MEMORANDUM

FROM: Joseph Dodson, Current Associate Planner

RE: Verona Live/Work – CUP (H-2021-0080)

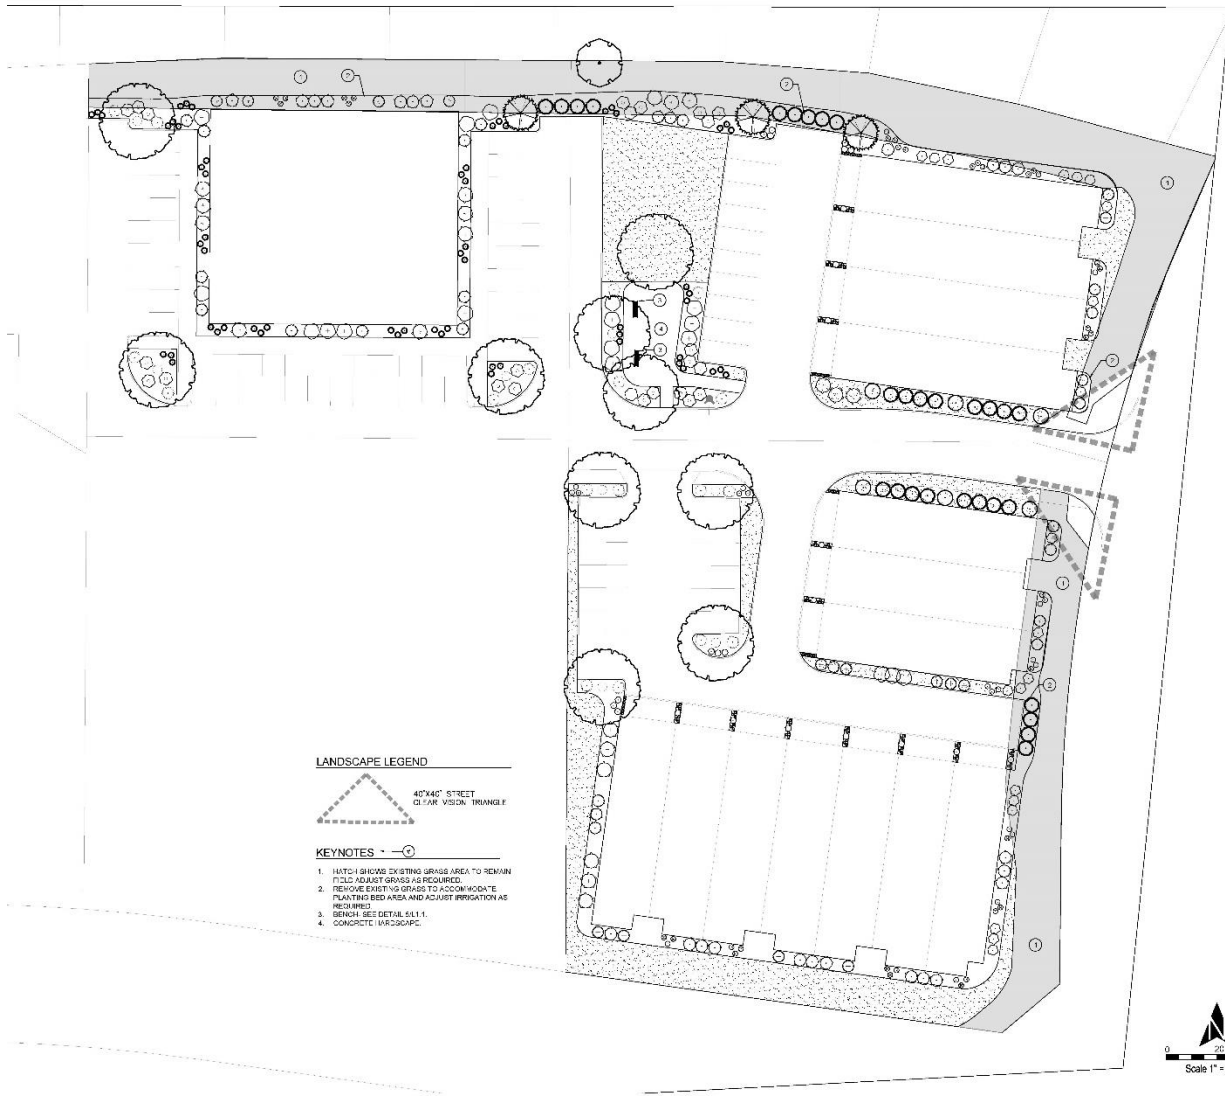
- **Revision to the north four (4) units** – Staff voiced concerns about the amount of commercial area shown within the proposed live/work floor plans. In conjunction with the loss of the two internal units and in response to Staff's comments, the Applicant has

revised the floor plan of the northern 4 units to be extended further west to accommodate an additional office space on the east side of the units facing Cortona Way. This has doubled the nonresidential area for these 4 units; the nonresidential area on the remaining 10 units has not changed.

C. Revised Conceptual Elevations and Floor Plans

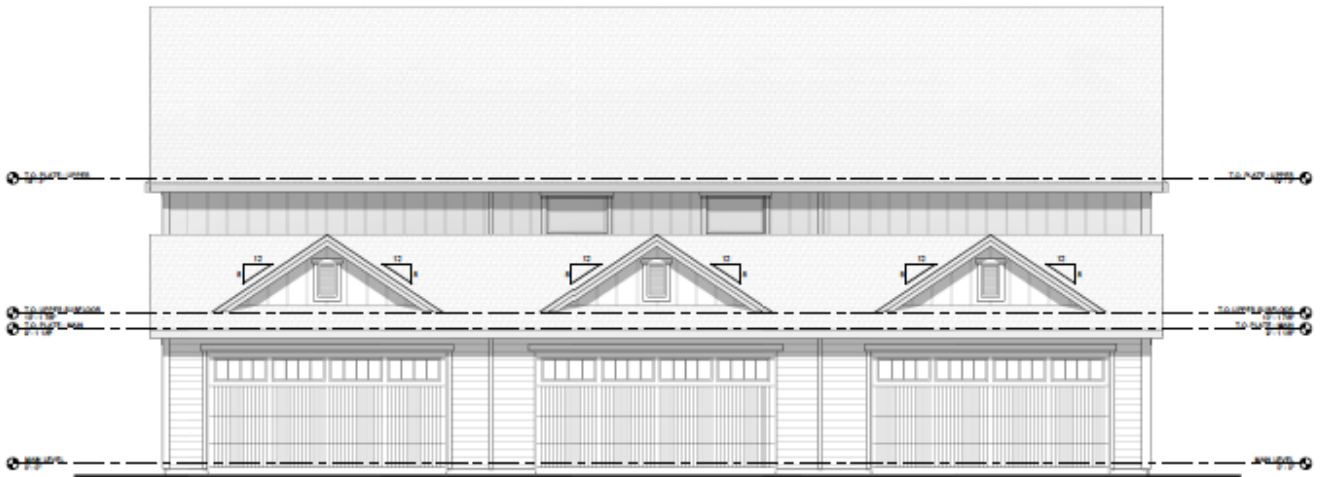
- **Revision to the conceptual elevations for the first floor façade for the nonresidential portion of the project** –Applicant revised the first floor façade of all of the buildings to include some of Staff’s recommended revisions noted in the conditions of approval in the staff report. Staff finds these revisions should add to the visibility and viability of the commercial spaces of the proposed units. Staff fully supports these revisions:

- First floor façade now includes a dedicated commercial entry door in addition to the internal shared access.
 - Façade incorporates nonresidential style awnings and shows area that would allow for signage space for future tenants/businesses.

- Applicant added taller windows on the first floor façade adjacent to the new commercial entry door to create more of a storefront consistent with nonresidential buildings; Staff finds this is an improvement from the original elevations that largely looked 100% residential.
